IEEE 802.3cb PCS compatibility to 1000BASE-X PCS

2017-09

Yong Kim

2.5x-GMII TX → XGMII RX, Issue – Lane 3 SFD

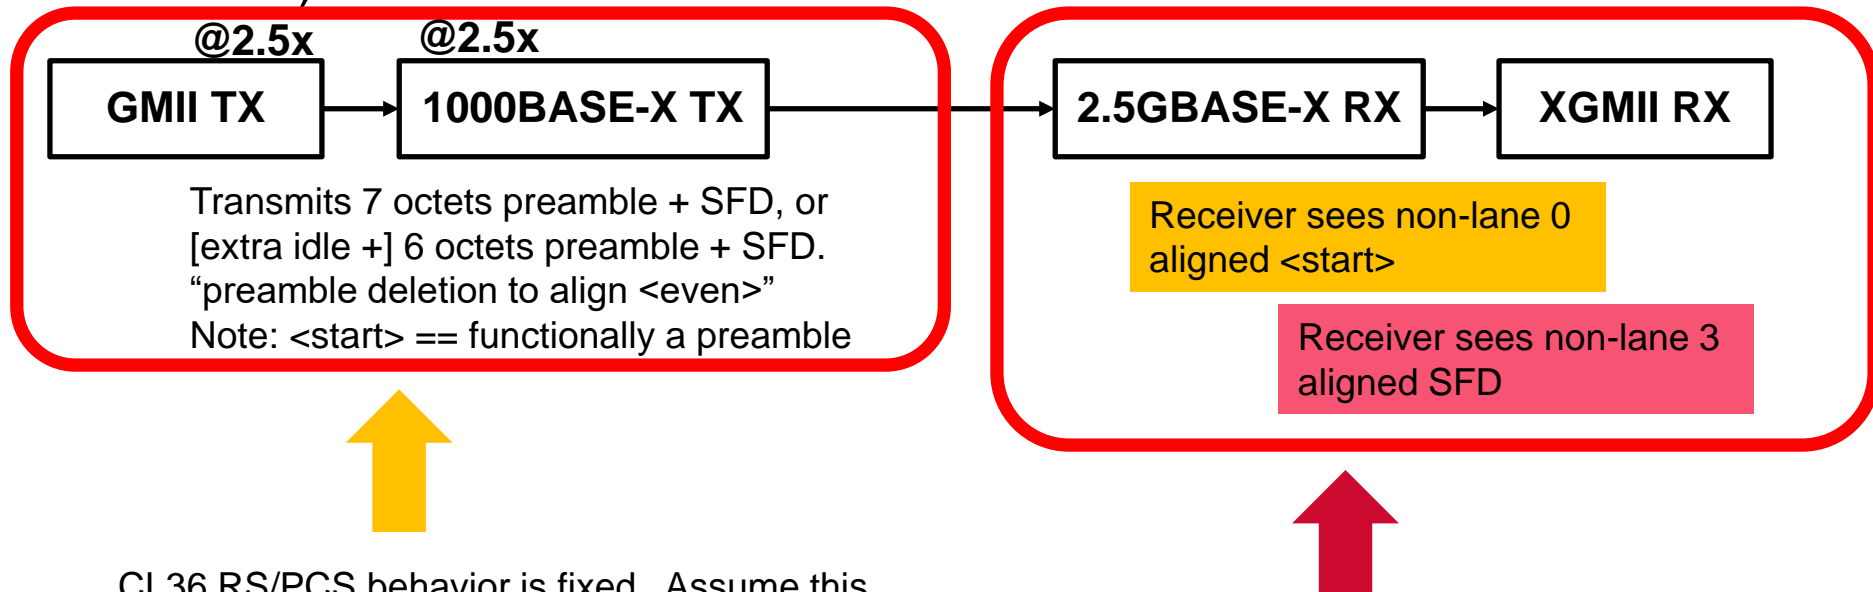
- CL46 XGMII lane 0 <start> and lane 3 SFD compatibility, when CL36 PCS sends extra idle bytes that replaces preamble (“odd-even alignment function”).

CL36 RS/PCS behavior is fixed. Assume this cannot be changed.

1. Any “repair work” could be done local to 2.5GBASE-X receive path. Any “repair work” should be done here.
2. Let’s see what it does.
3. Let’s see what it should do.

2.5GBASE-X Receive Path (MDI → XGMII)

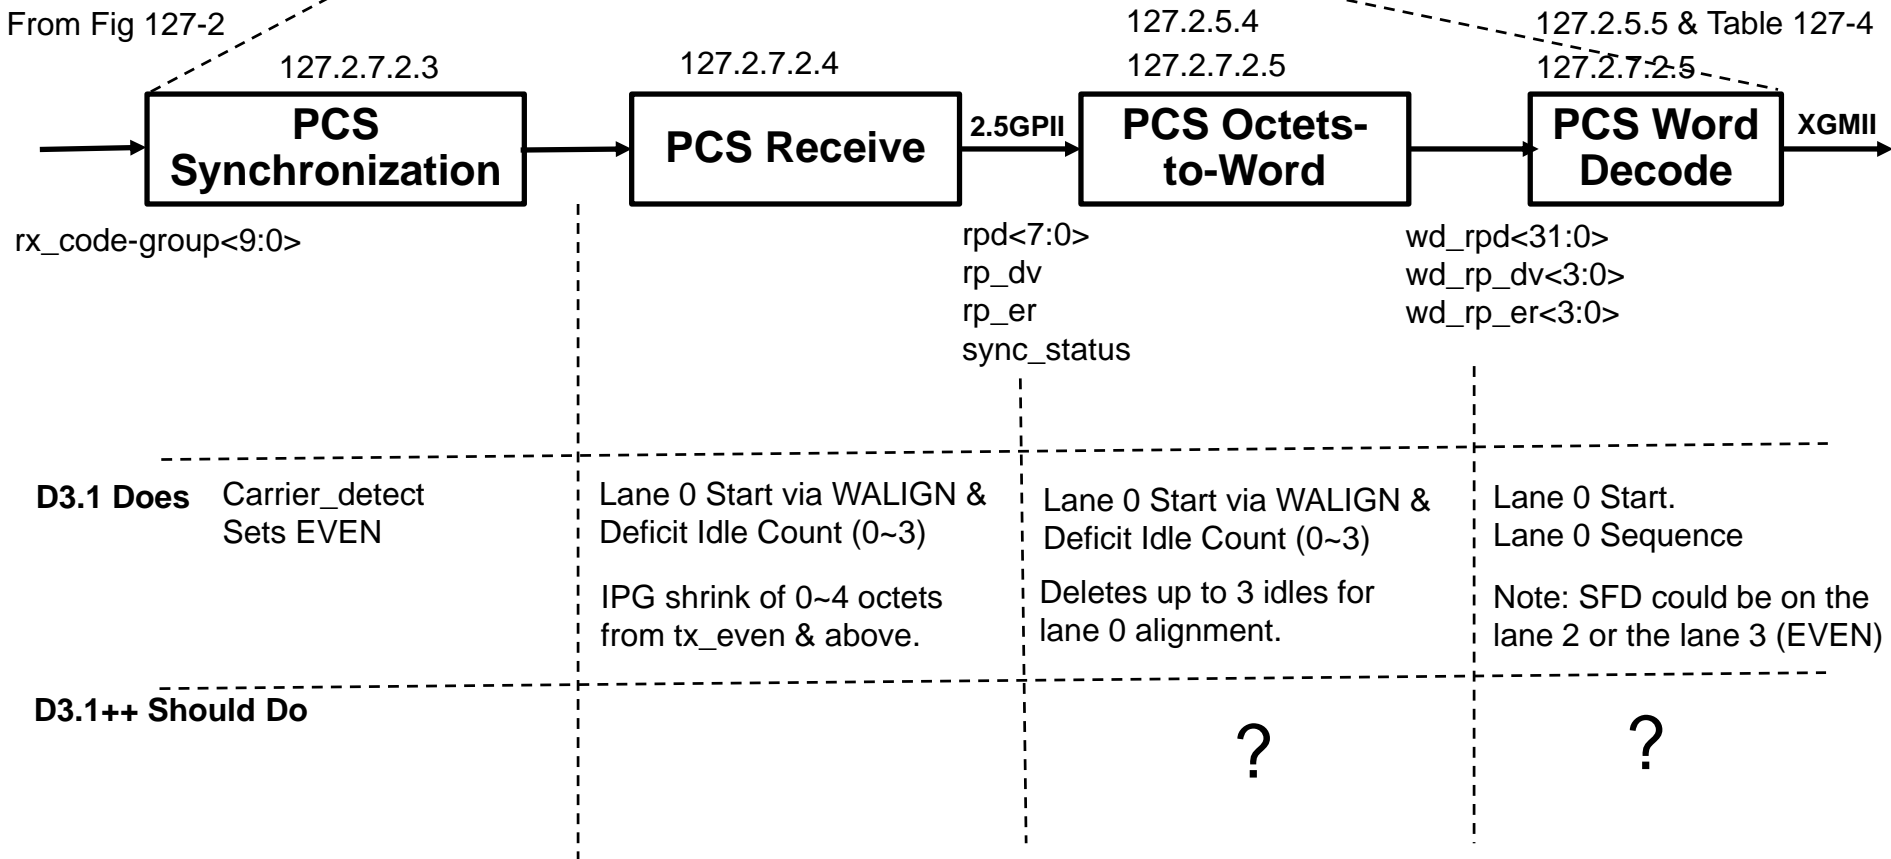
Observations WRT possible remedy
